Project Name: PEARL JUNIOR HIGH MULTIPURPOSE  
Project No: 22-056

## ADDENDUM NO. 04

**C302**  
 STORM DRAIN LAYOUT

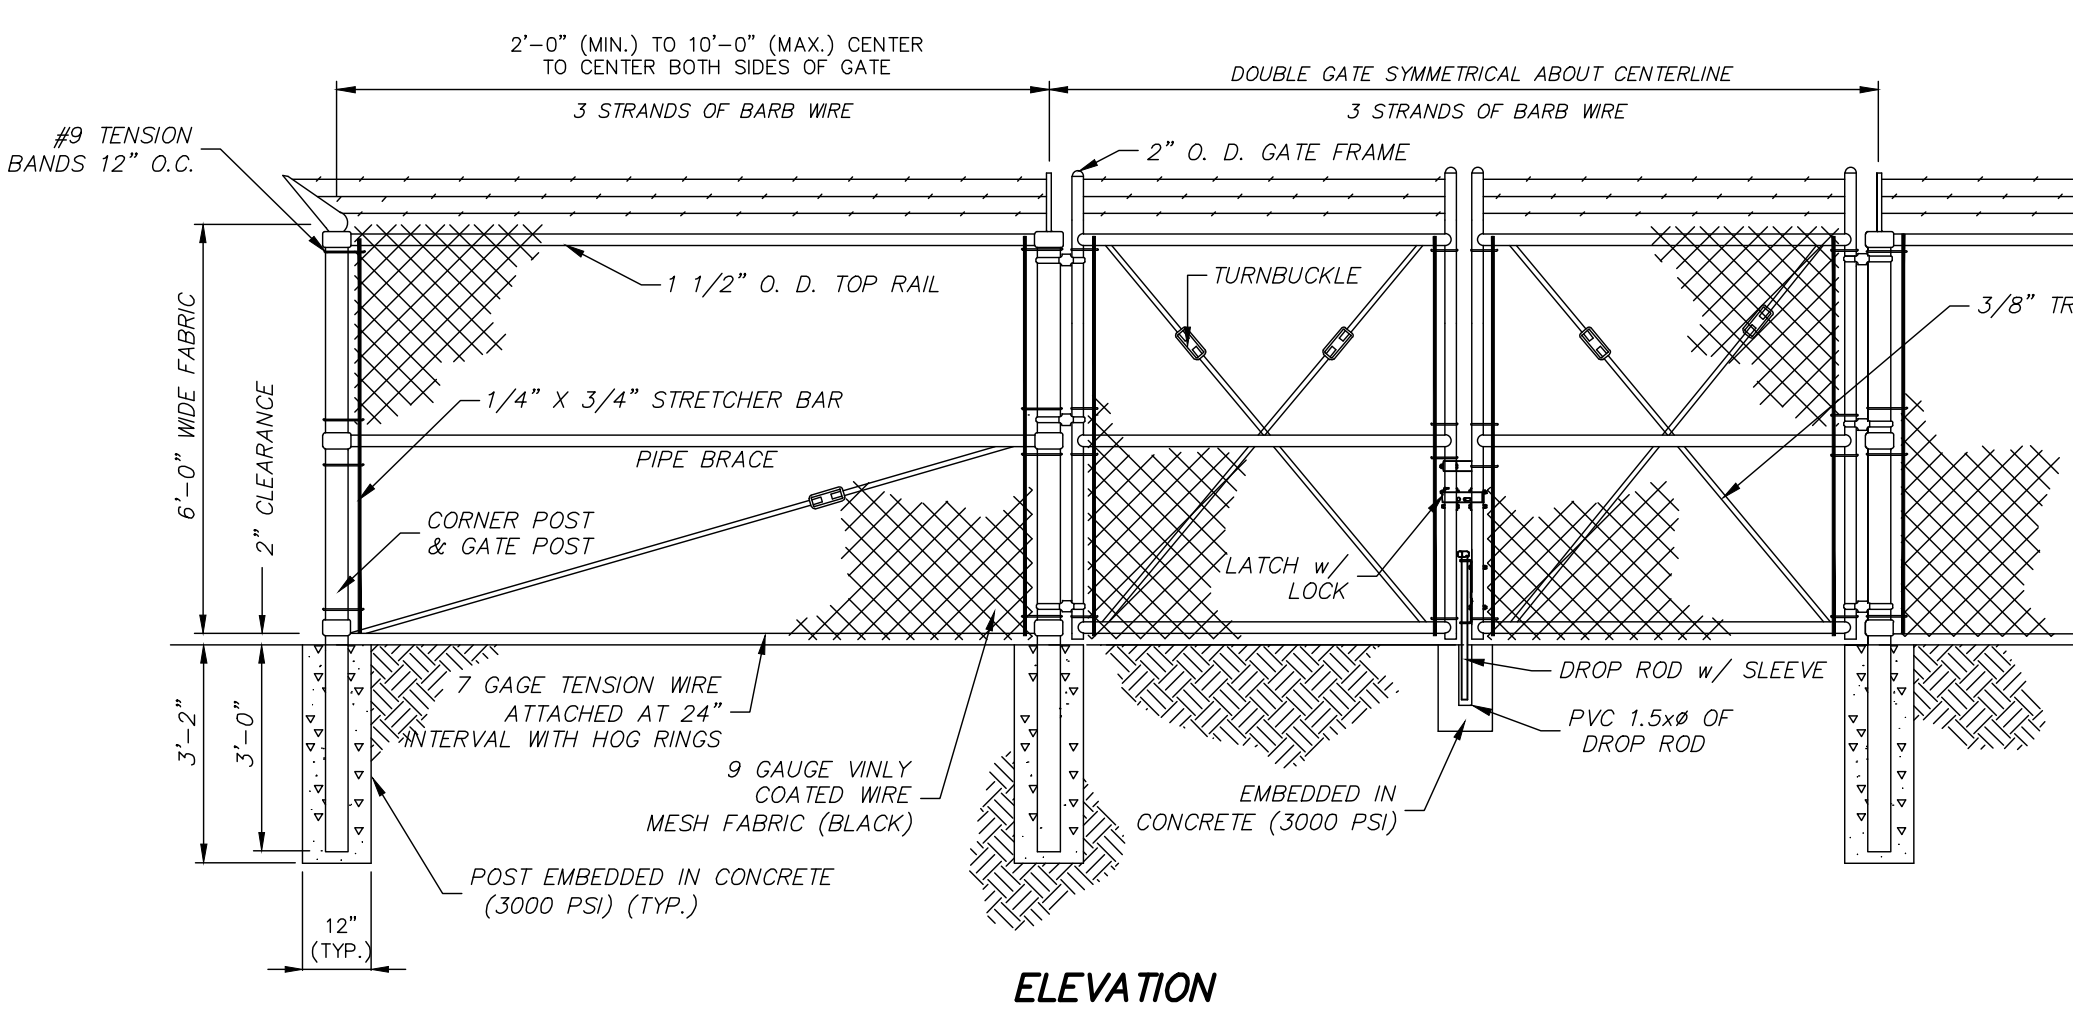
| C302 | STORM DRAIN LAYOUT         | <ul style="list-style-type: none"><li>• Clarification of new French drain around new building.</li></ul>  |

C400  
 GENERAL CONST. NOTES

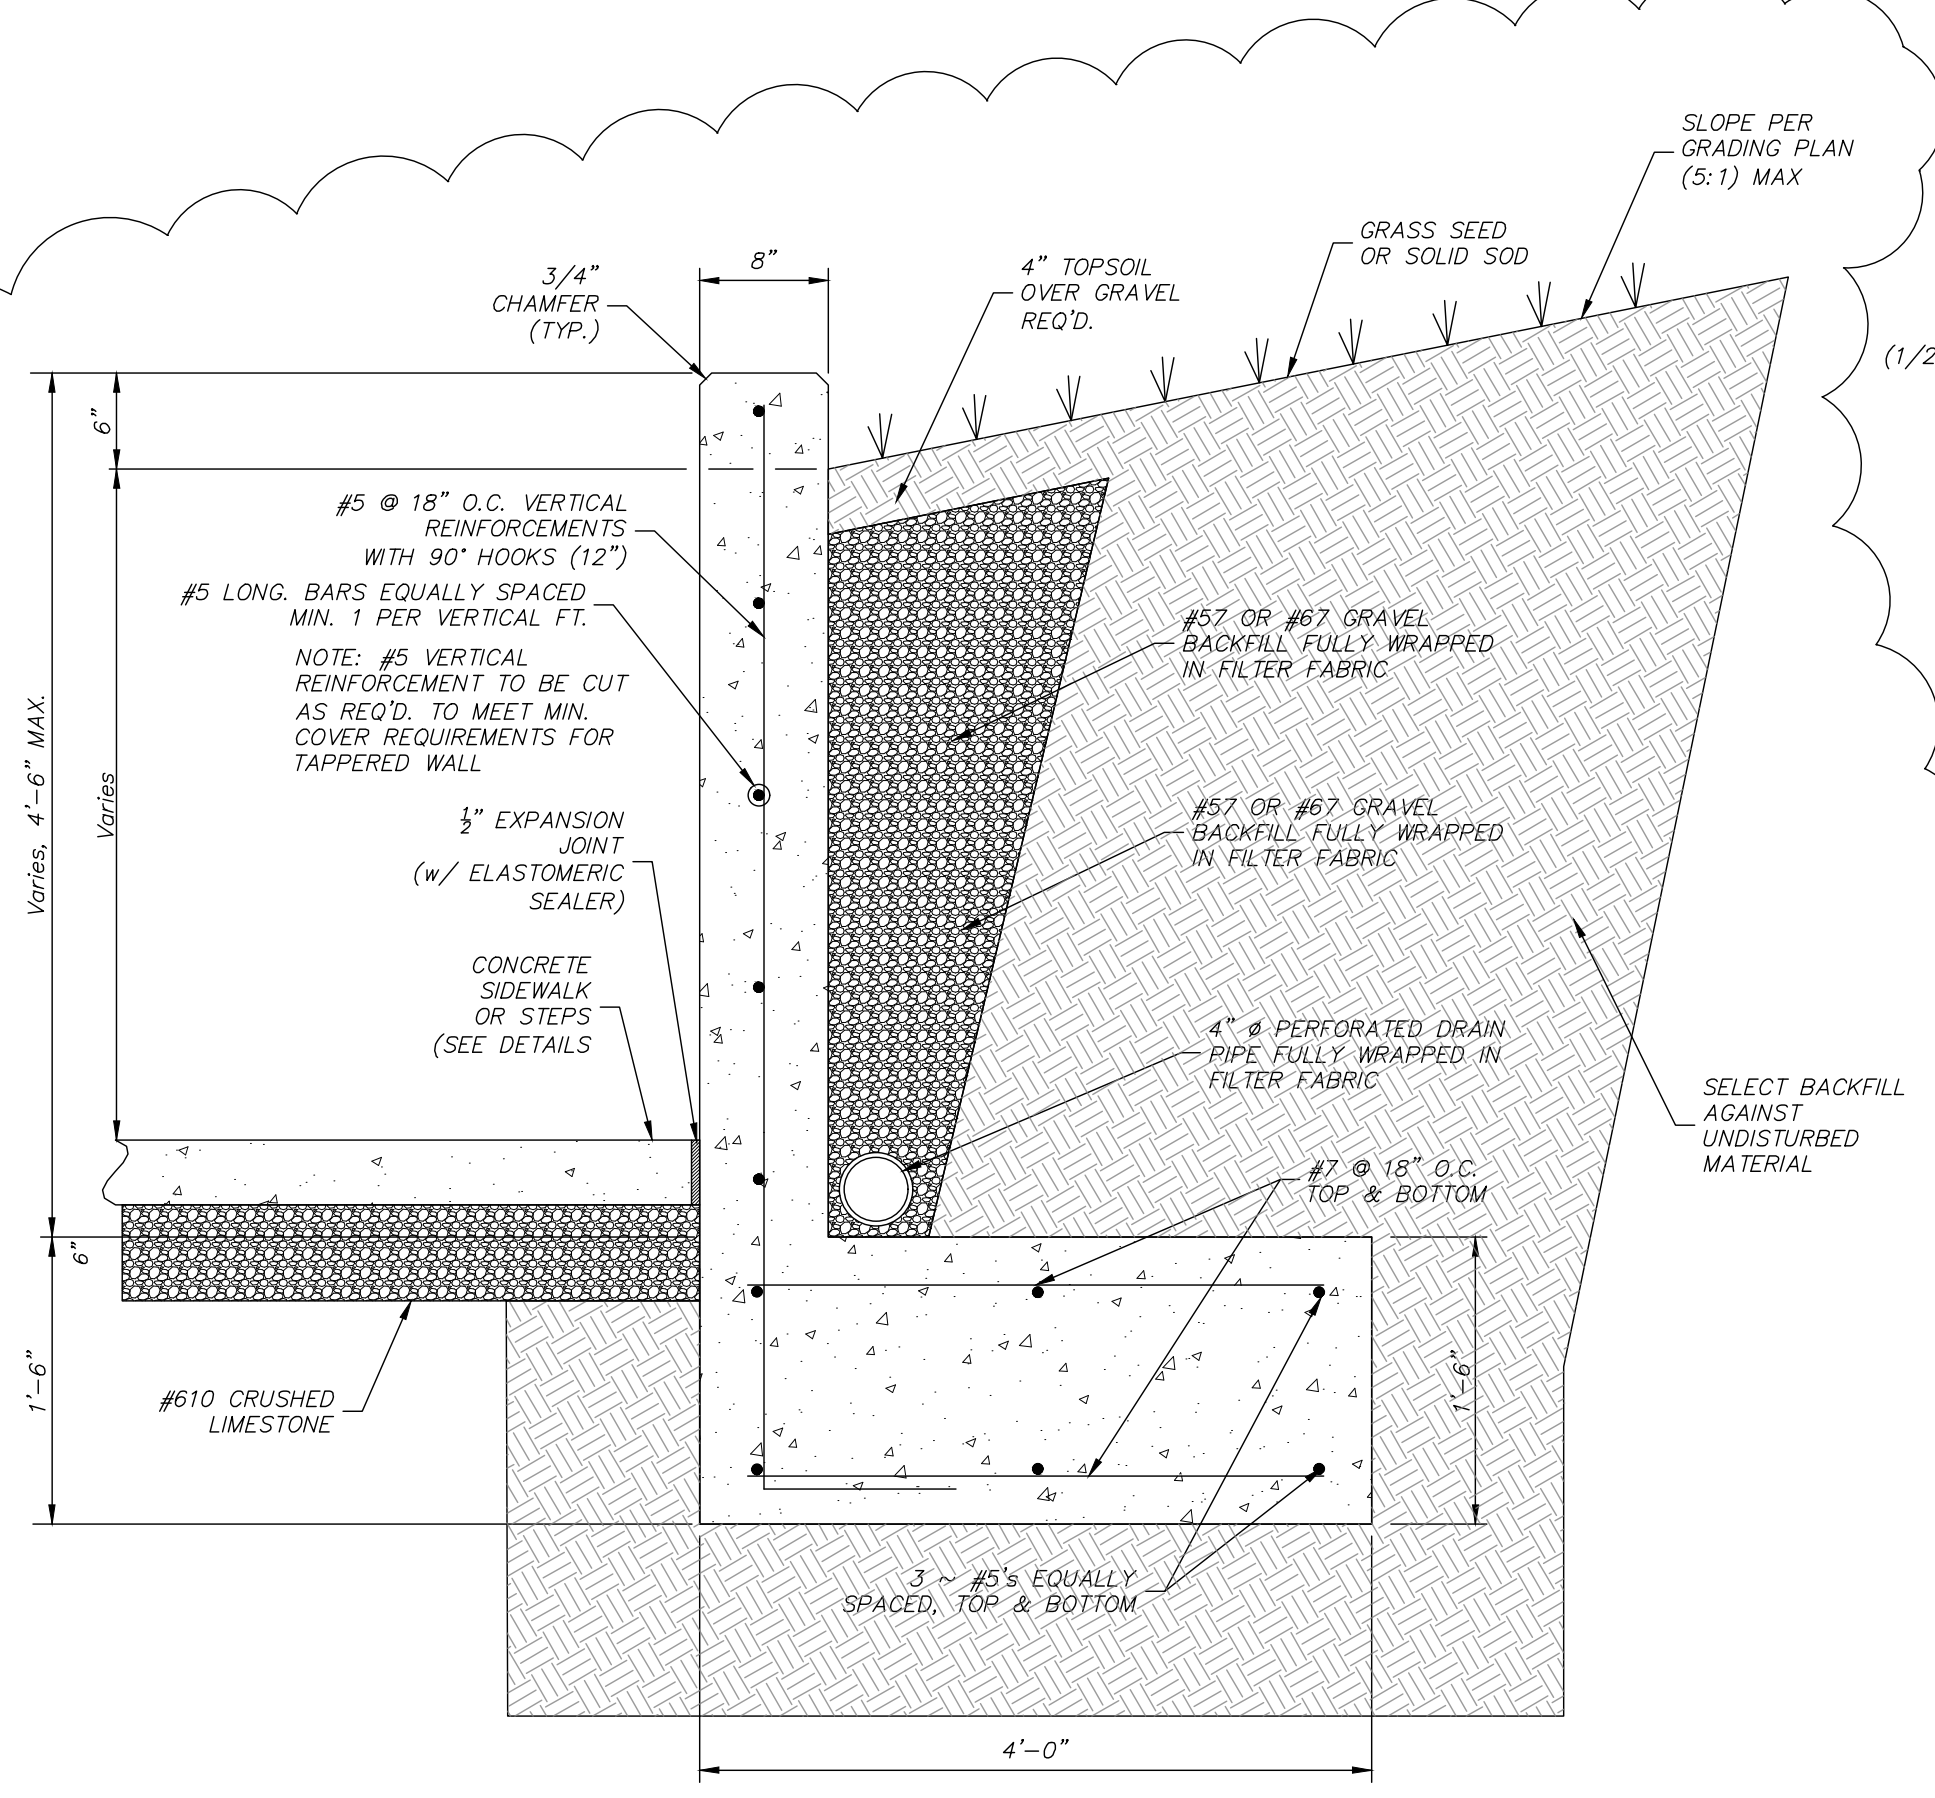
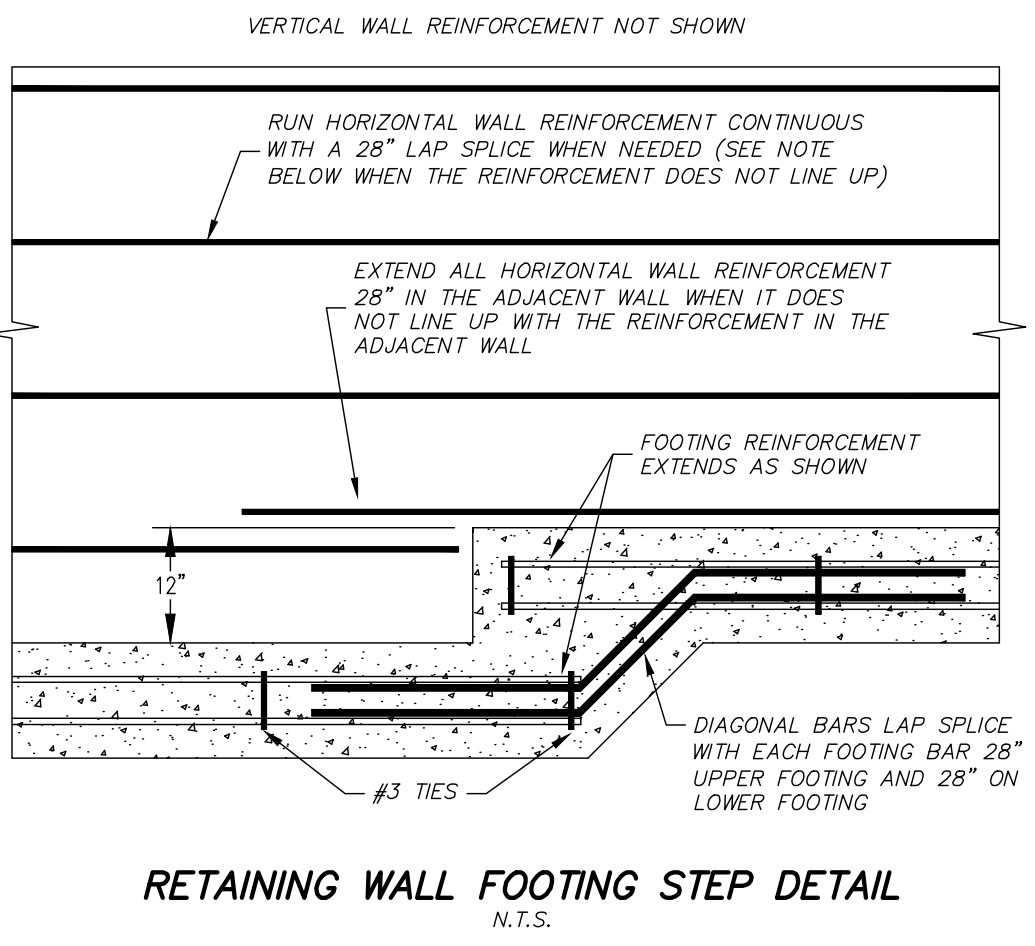
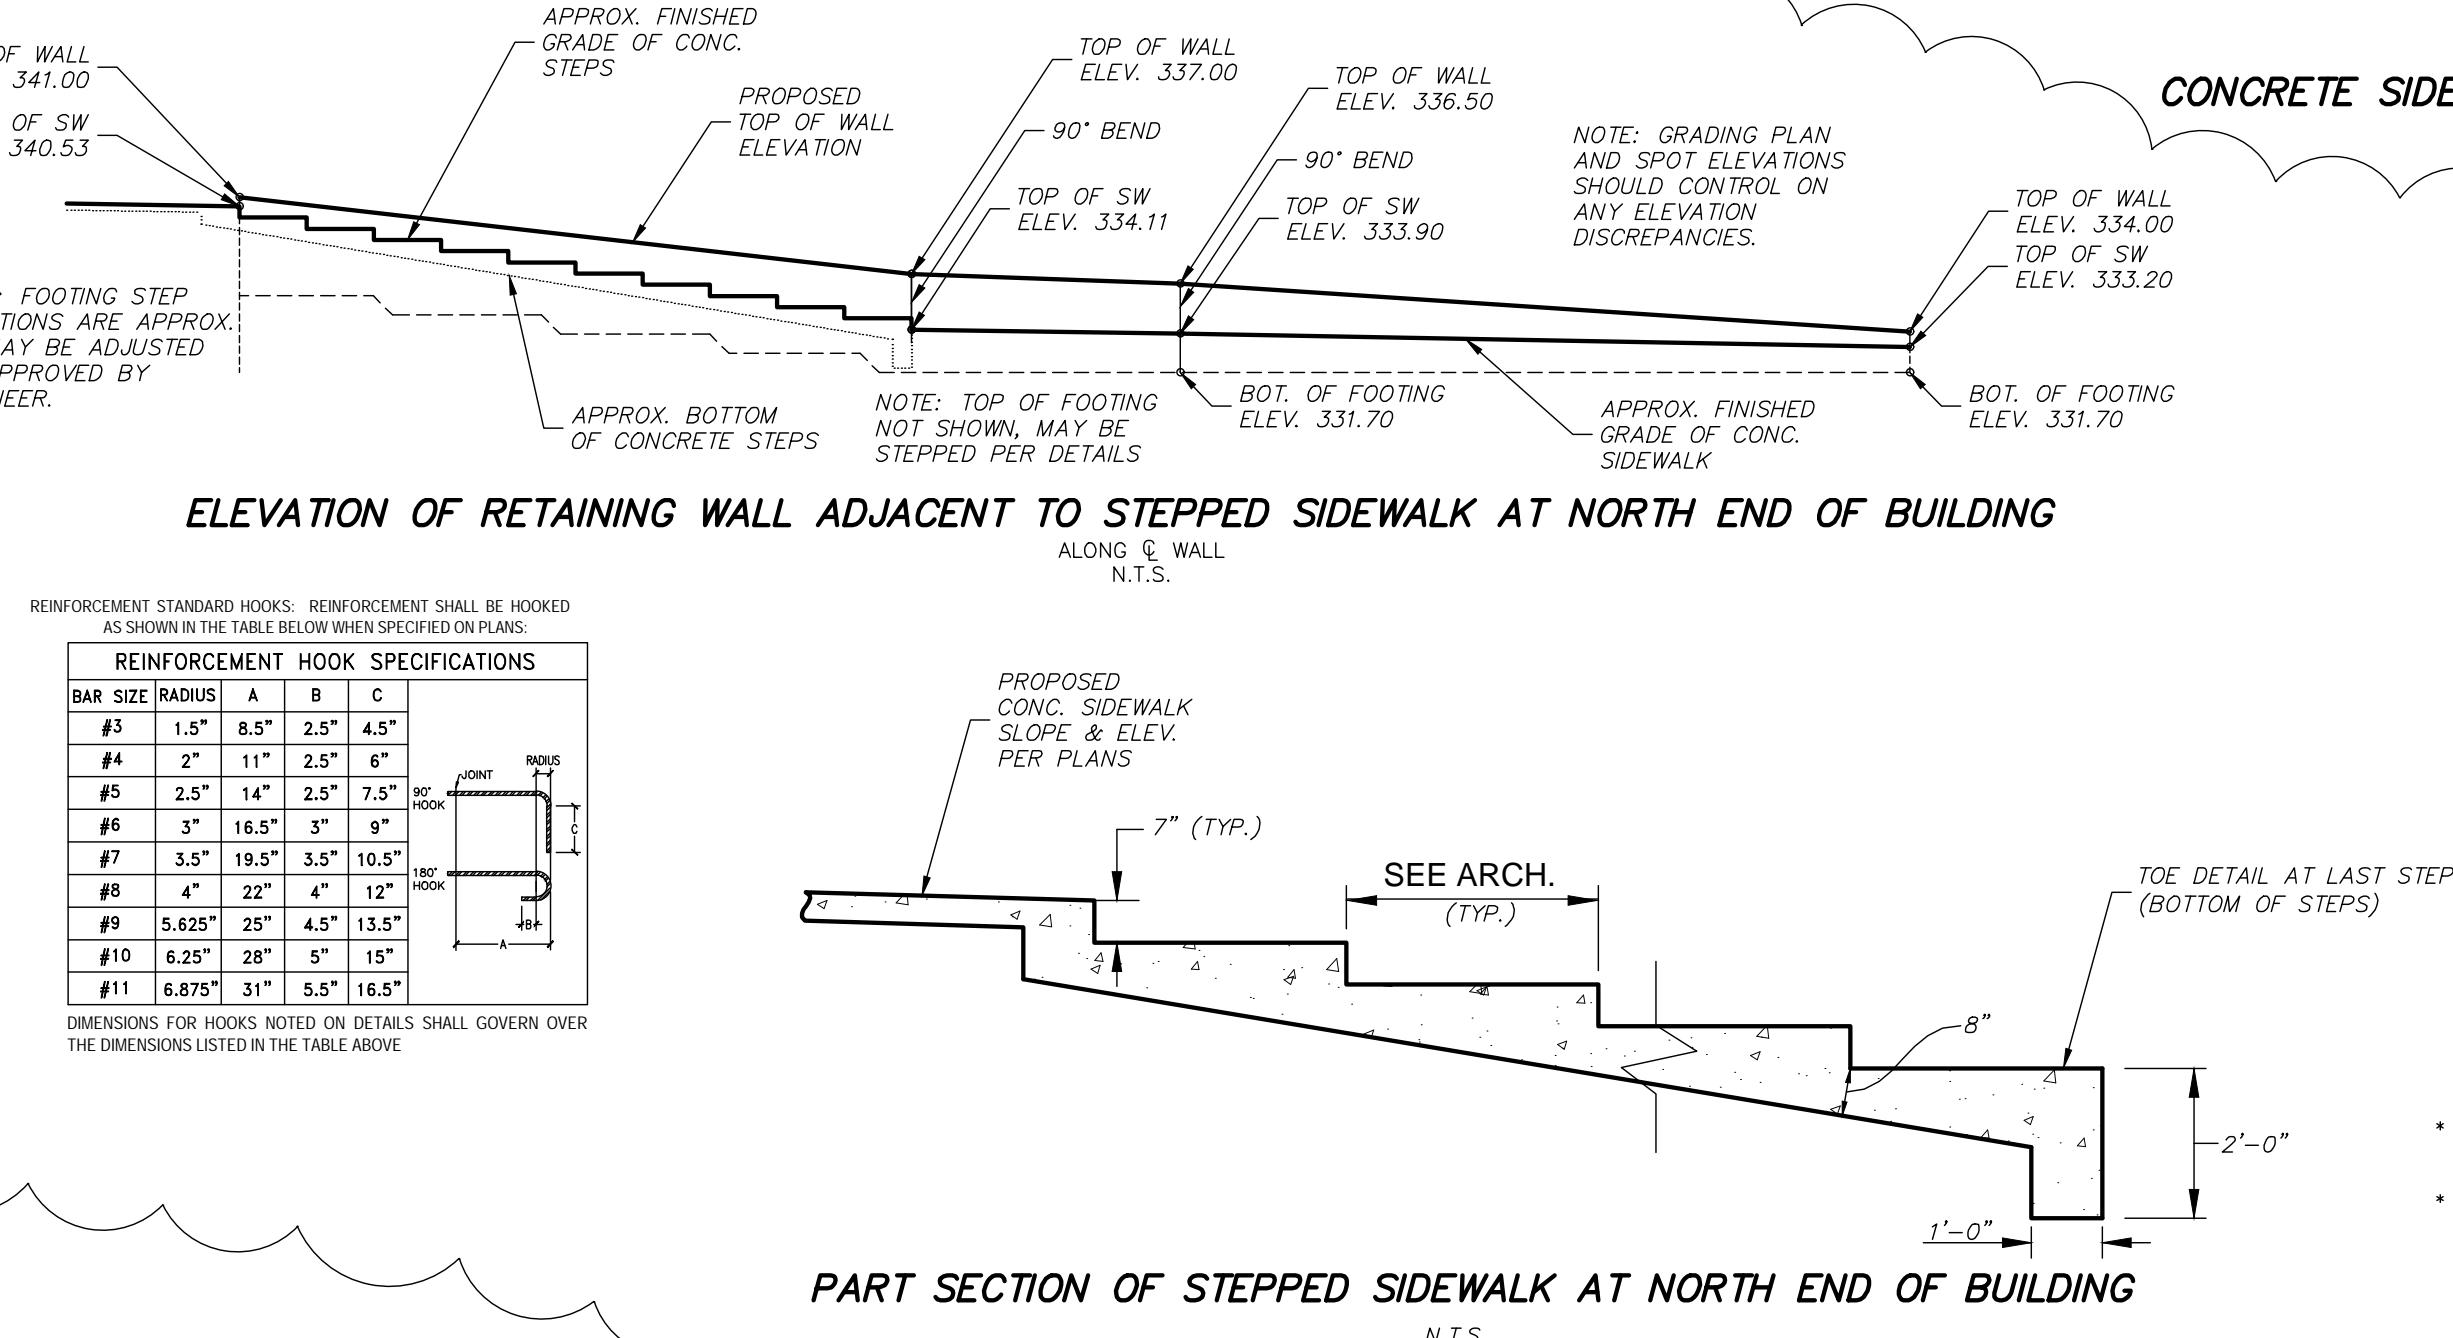
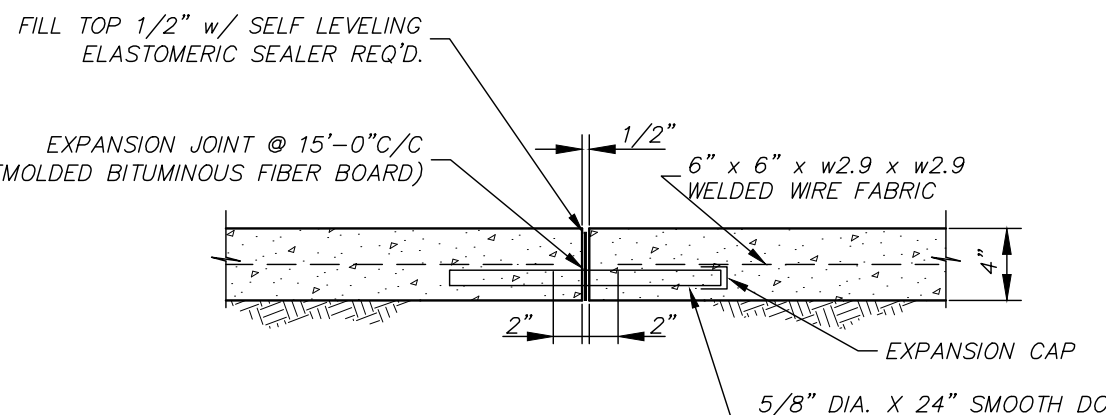
| C400 | GENERAL CONSTRUCTION NOTES | <ul style="list-style-type: none"><li>• Added details for the retaining wall and steps on the north side of the existing building.</li></ul>            |
